COUNTY ROAD 595 STREAM CROSSINGS

MARQUETTE COUNTY, MICHIGAN

REVISIONS THIS SET:

- SHEETS ADDED WTAS, W1AP,W1S, W1P, W2S, W2P, 17S AND 17P
- SHEETS OMITTED 2S, 2P, 3S, , 4S, 4P, 12S, AND 12P
- SHEETS REVISED A1, 1S, 1P, 1AS, 1AP, 5S, 6S, 6P, 7S, 7P, 8S, 8P, 9S, 9P, 10S, 10P, 11S, 11P, 13S, 13P, 14S, 14P, 15S, 15P, AND 16S

STREAM BOX CULVERT E1W UNNAMED TRIBUTARY TO MIDDLE BRANCH ESCANABA RIVER STA 1+67

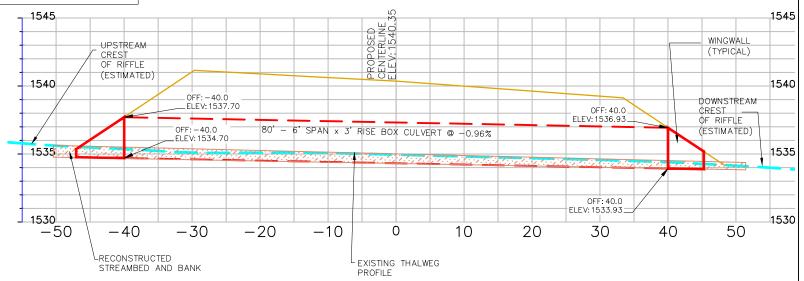
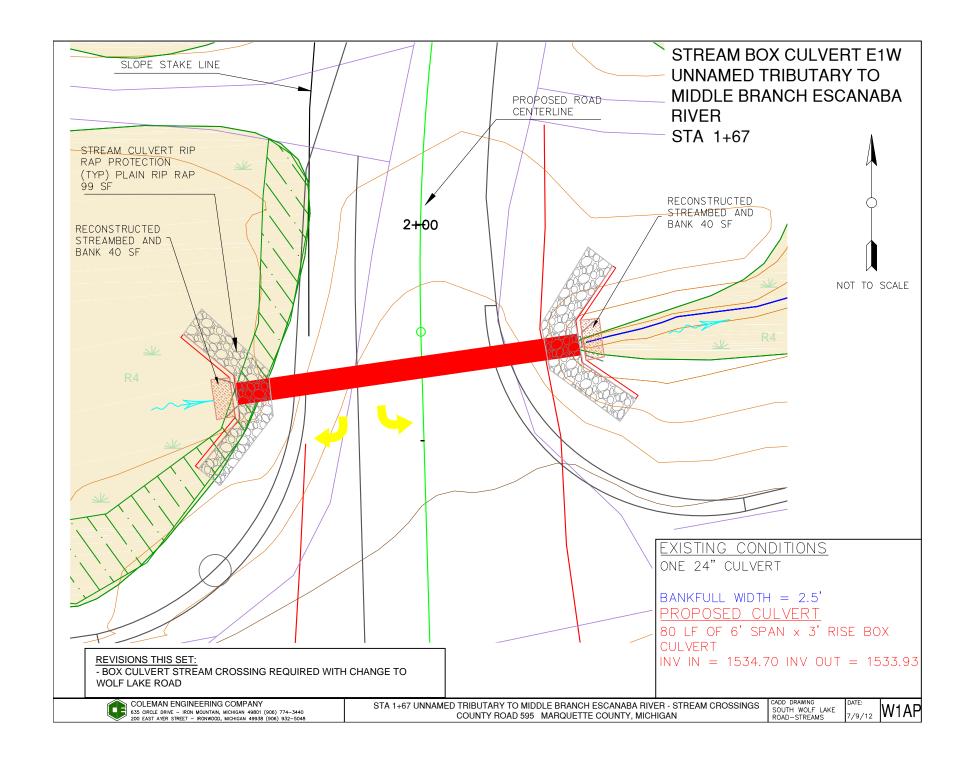
- BOX CULVERT STREAM CROSSING REQUIRED WITH CHANGE TO WOLF LAKE ROAD

STREAM BOX CULVERT E4W UNNAMED STREAM STA 23+65

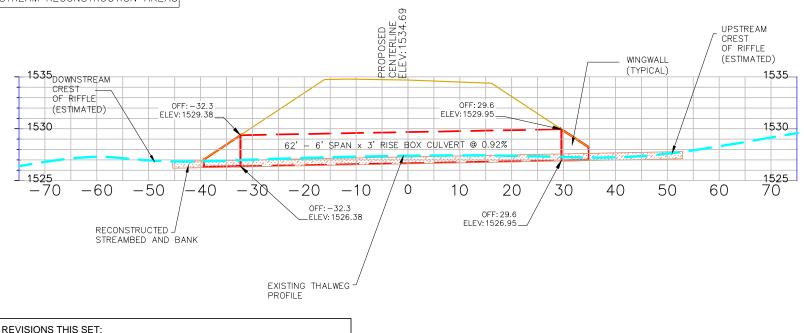
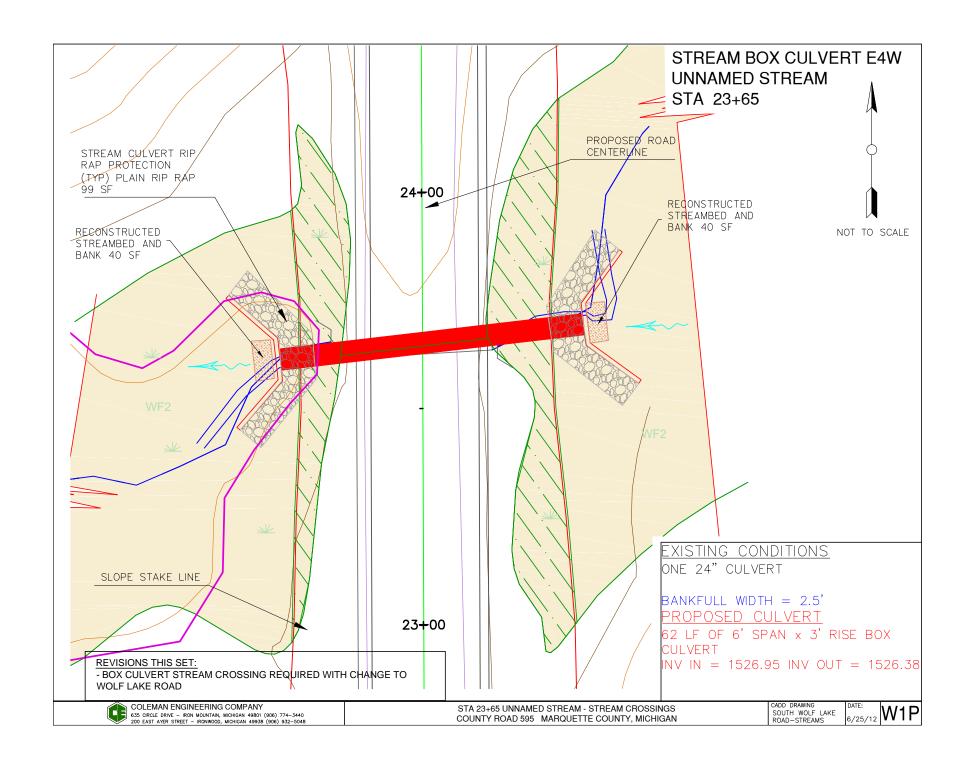
WOLF LAKE ROAD

- BOX CULVERT STREAM CROSSING REQUIRED WITH CHANGE TO

STREAM BOX CULVERT E5W **UNNAMED STREAM** STA 32+40

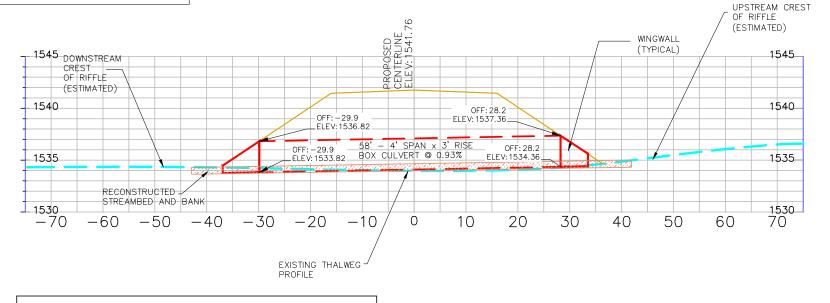
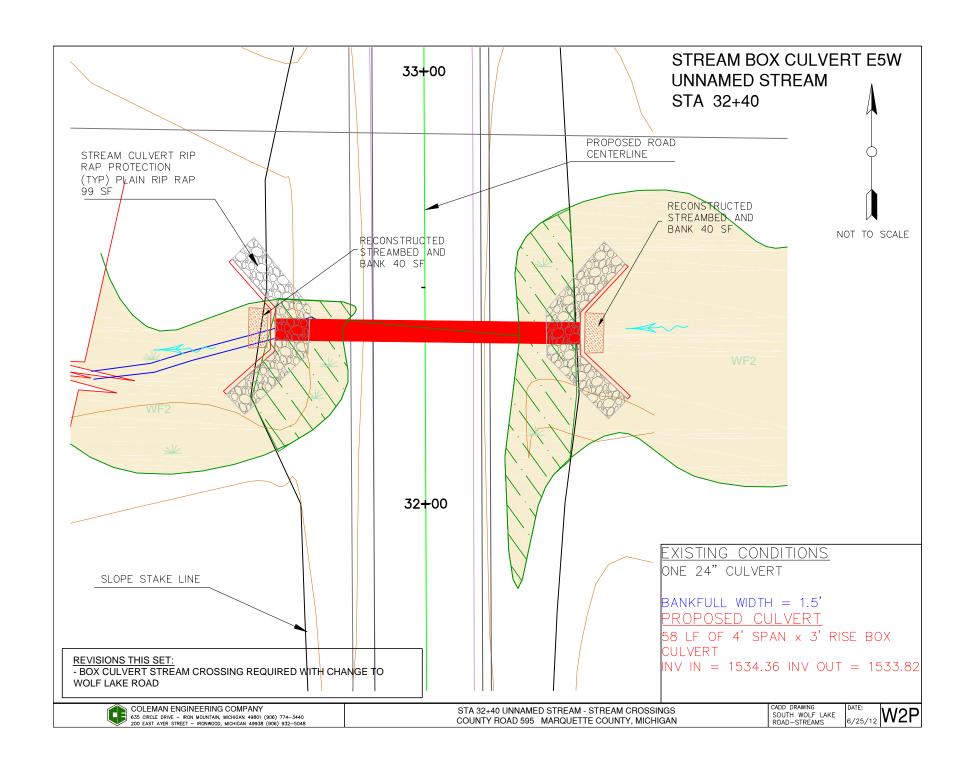
- BOX CULVERT STREAM CROSSING REQUIRED WITH CHANGE TO WOLF LAKE ROAD

STREAM BOX CULVERT E6

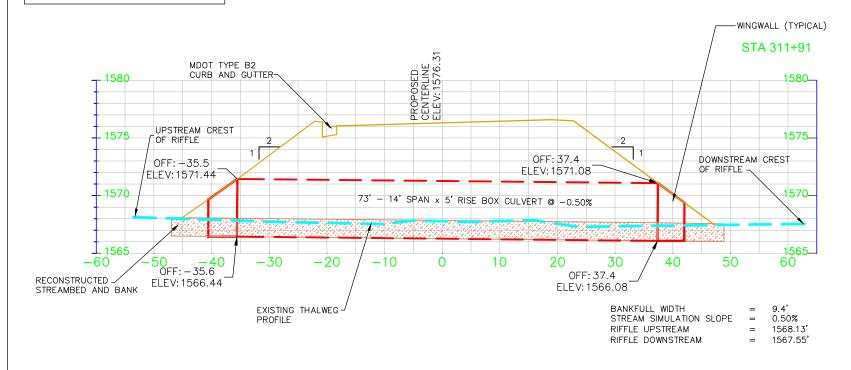
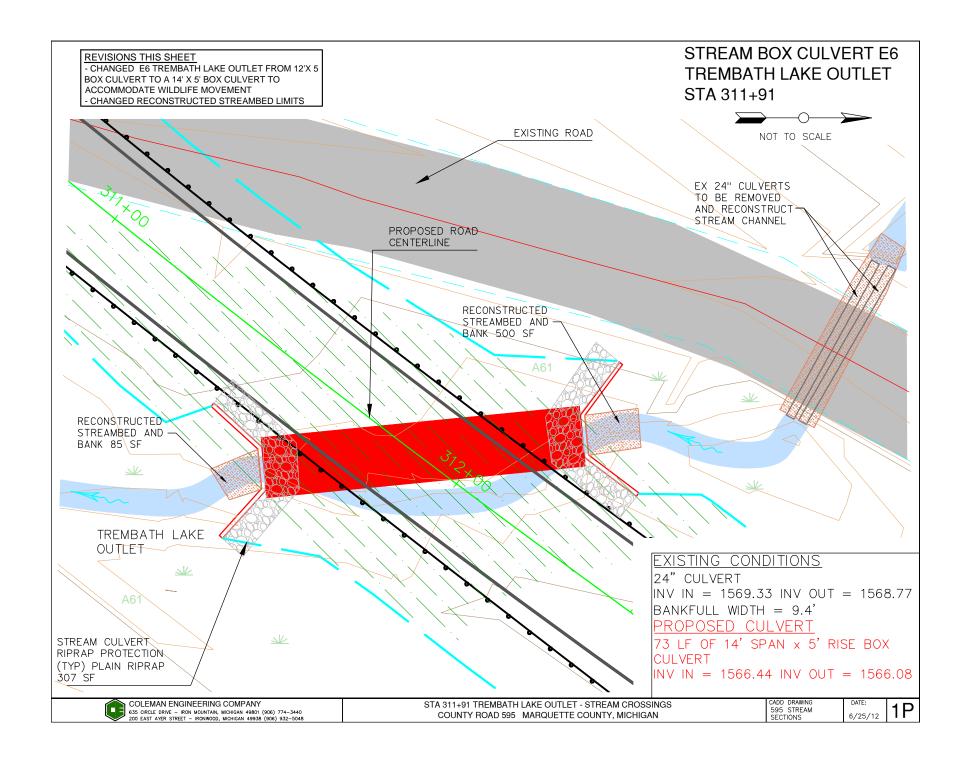
- CHANGED E6 TREMBATH LAKE OUTLET FROM 12'X 5 BOX CULVERT TO A 14' X 5' BOX CULVERT TO ACCOMMODATE WILDLIFE MOVEMENT - ADD MAINTAINING BANKFULL WIDTH NOTE

14' SPAN x 5' RISE BOX

STREAM BOX CULVERT E99 UNNAMED STREAM STA 426+47

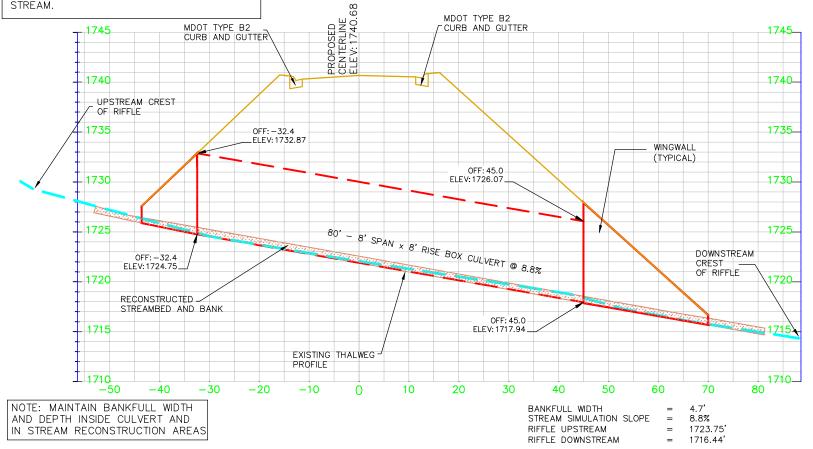
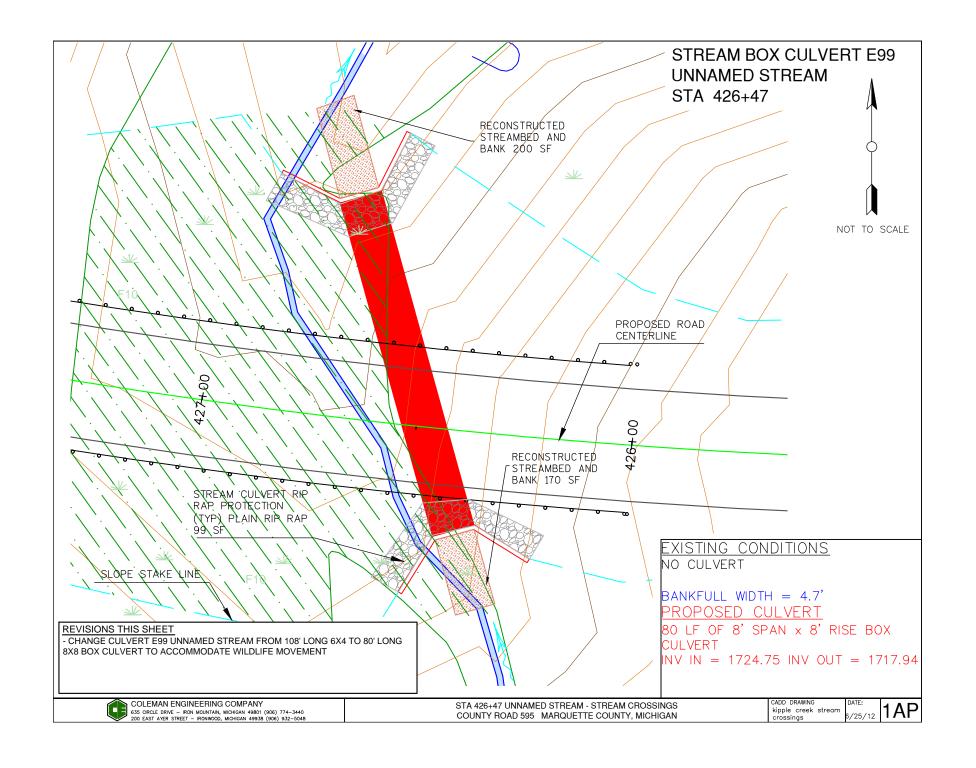
- -ADDITION OF MOOT TYPE B2 CURB AND GUTTER
- -CHANGED PROPOSED CENTERLINE ELEV: 1739.77 TO PROPOSED CENTERLINE ELEV: 1740.68
- STREAM BOX CULVERT D103 UNNAMED STREAM STA 3023+75 TO STREAM BOX CULVERT E99 UNNAMED STREAM STA 426+47 -CHANGED CULVERT E99 UNNAMED STREAM FROM 108' LONG 6X4 TO 80' LONG 8X8 BOX CULVERT TO ACCOMMODATE WILDLIFE MOVEMENT
- ADD MAINTAINING BANKFULL WIDTH NOTE

STREAM BOX CULVERT D28 UNNAMED TRIBUTARY TO VOELKERS CREEK STA 1219+67

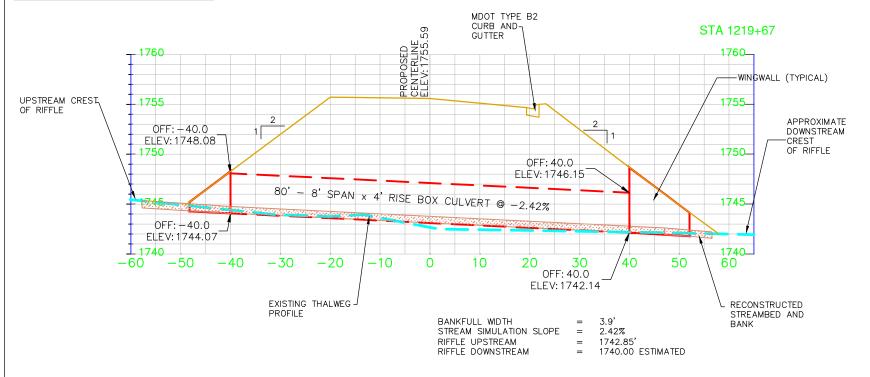
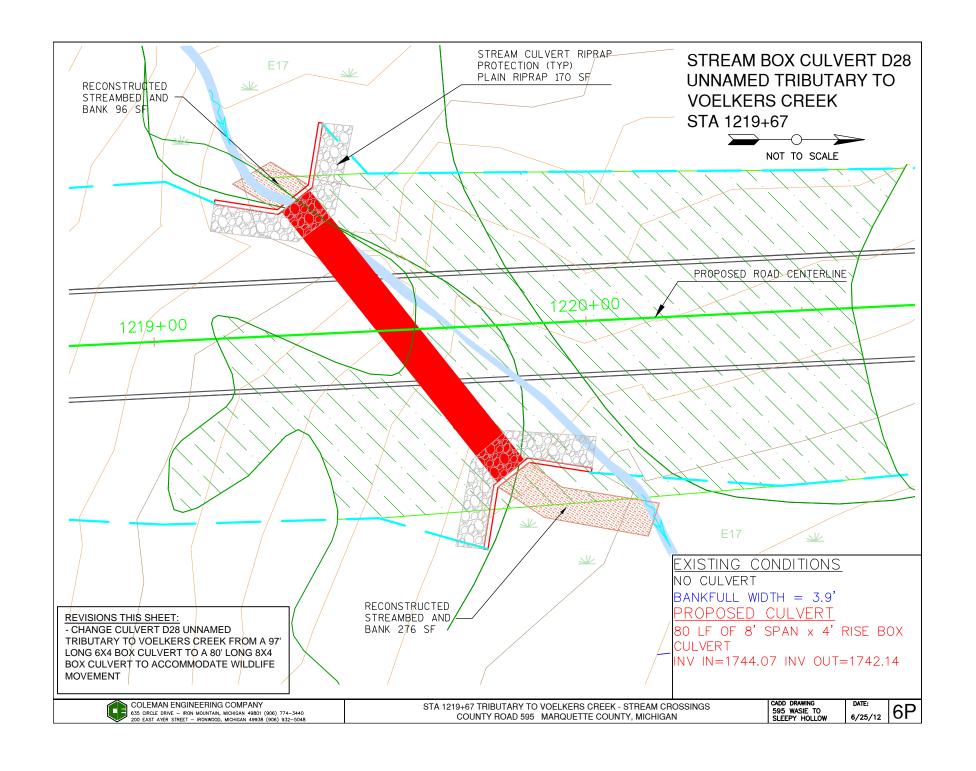
- CHANGE CULVERT D28 UNNAMED TRIBUTARY TO VOELKERS CREEK FROM A 97' LONG 6X4 BOX CULVERT TO A 80' LONG 8X4 BOX CULVERT TO ACCOMMODATE WILDLIFE MOVEMENT

STREAM BOX CULVERT D44 WILDCAT CANYON CREEK STA 1404+15

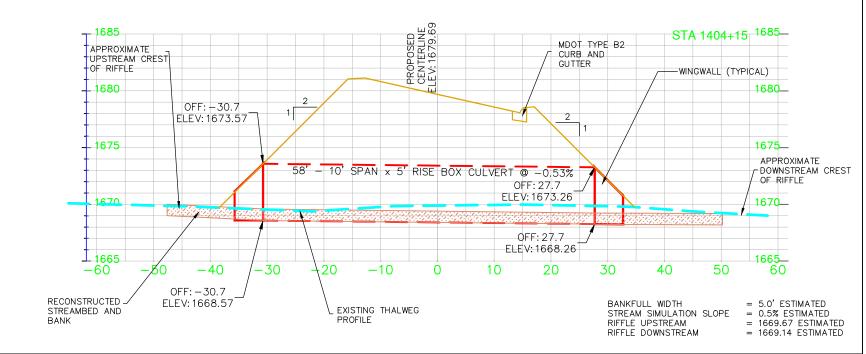
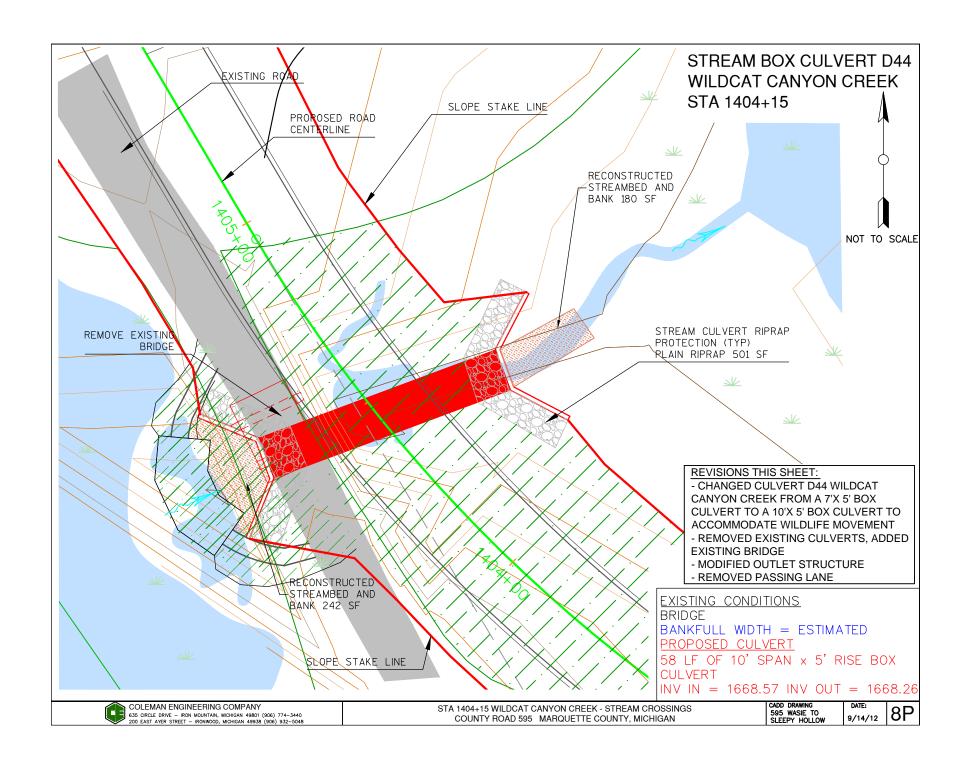
- CHANGED CULVERT D44 WILDCAT CANYON CREEK FROM A 7'X 5' BOX CULVERT TO A 10'X 5' BOX CULVERT TO ACCOMMODATE WILDLIFE MOVEMENT
- ADD MAINTAINING BANKFULL WIDTH NOTE
- REMOVED EXISTING CULVERT TO BE REMOVED NOTE
- REMOVED PASSING LANE

STREAM BOX CULVERT D46 WILDCAT CANYON CREEK STA 1418+67

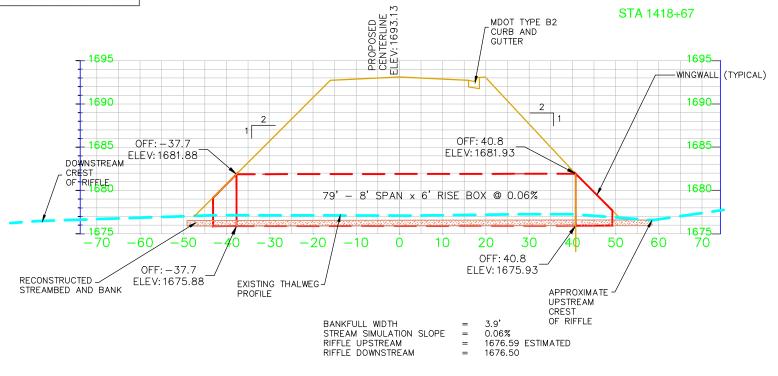
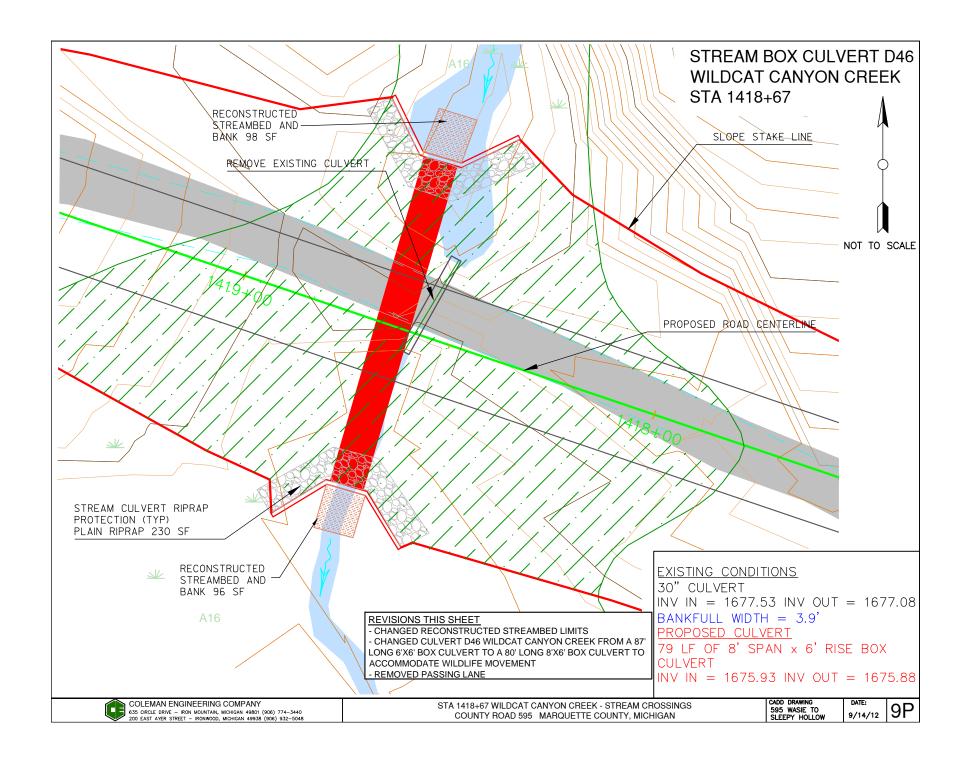
- CHANGED CULVERT D46 WILDCAT CANYON CREEK FROM A 87' LONG 6'X6' BOX CULVERT TO A 80' LONG 8'X6' BOX CULVERT TO ACCOMMODATE WILDLIFE MOVEMENT - ADD MAINTAINING BANKFULL WIDTH NOTE - REMOVED PASSING LANE

STREAM BOX CULVERT D47 UNNAMED TRIBUTARY TO WILDCAT CANYON CREEK STA 1423+13

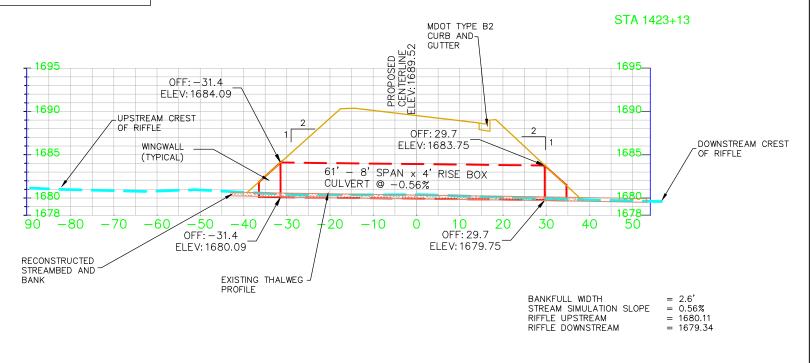
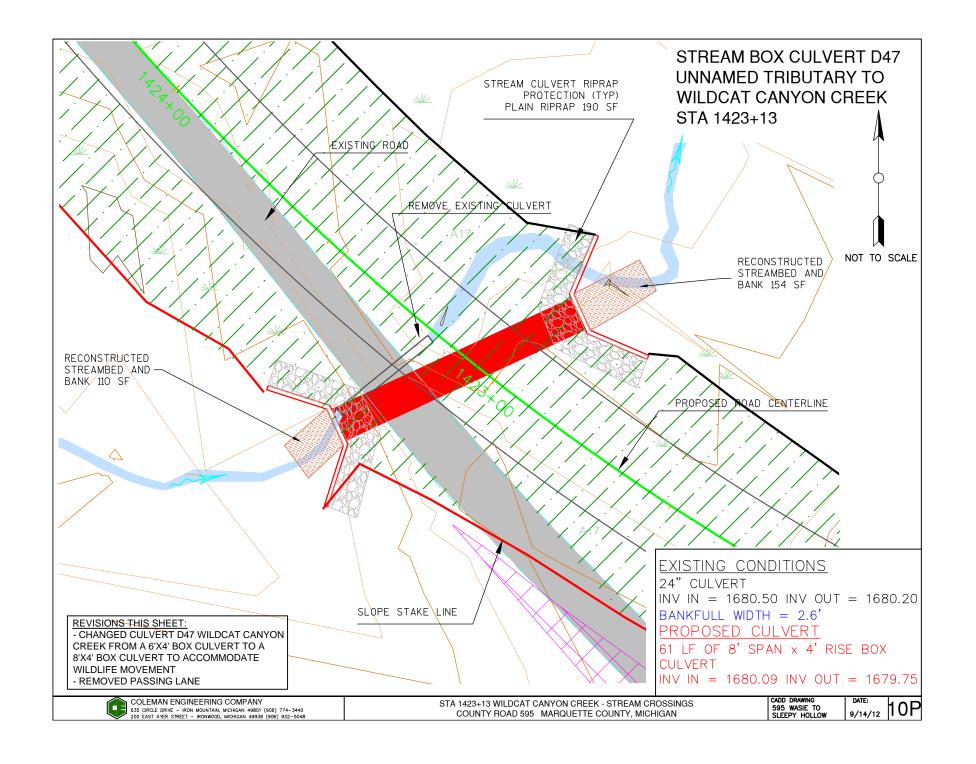
- CHANGED CULVERT D47 WILDCAT CANYON CREEK FROM A 6'X4' BOX CULVERT TO A 8'X4' BOX CULVERT TO ACCOMMODATE WILDLIFE MOVEMENT
- ADD MAINTAINING BANKFULL WIDTH NOTE
- REMOVED PASSING LANE

TYPICAL SECTION 8' SPAN x 4' RISE BOX

STREAM BOX CULVERT D59 UNNAMED TRIBUTARY TO MULLIGAN CREEK STA 1513+27

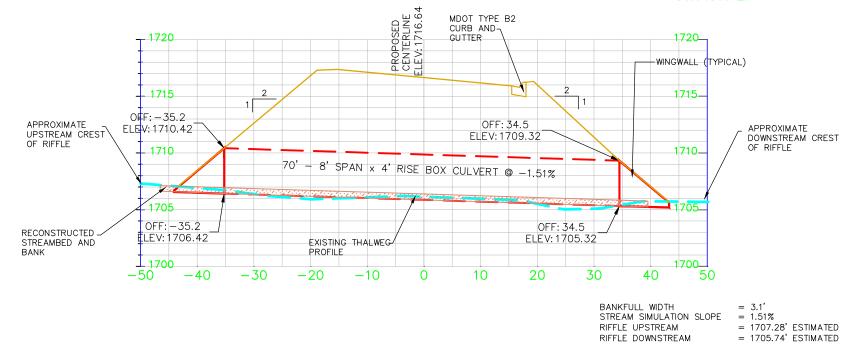
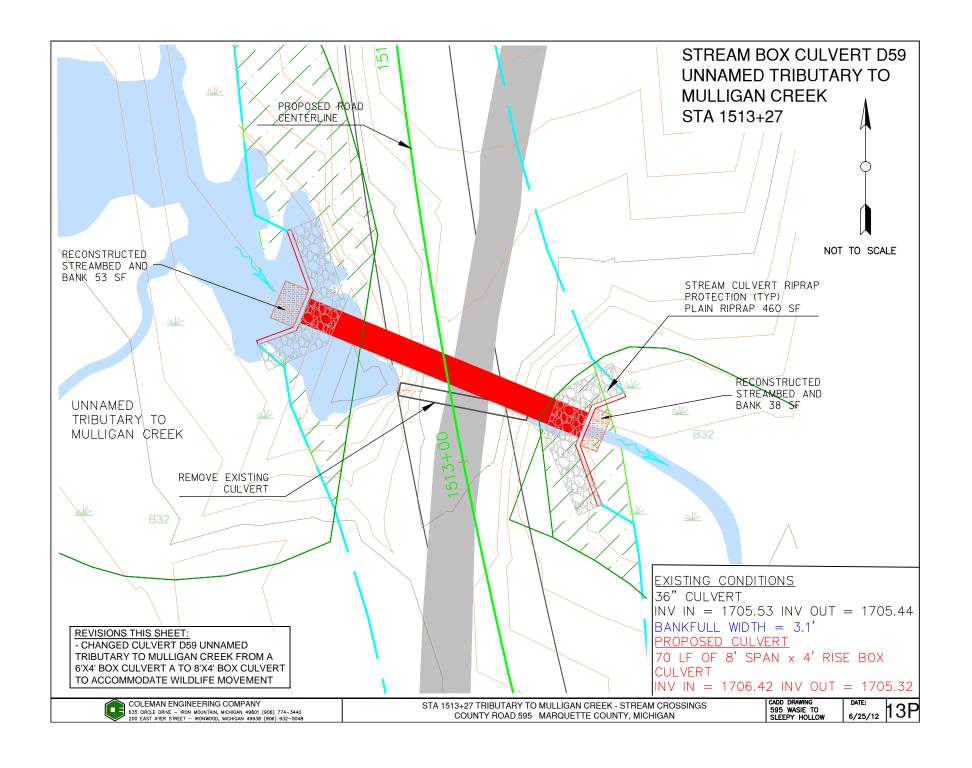
- CHANGED CULVERT D59 UNNAMED TRIBUTARY
TO MULLIGAN CREEK FROM A 6'X4' BOX
CULVERT TO 8'X4' BOX CULVERT TO
ACCOMMODATE WILDLIFE MOVEMENT
- ADD MAINTAINING BANKFULL WIDTH NOTE
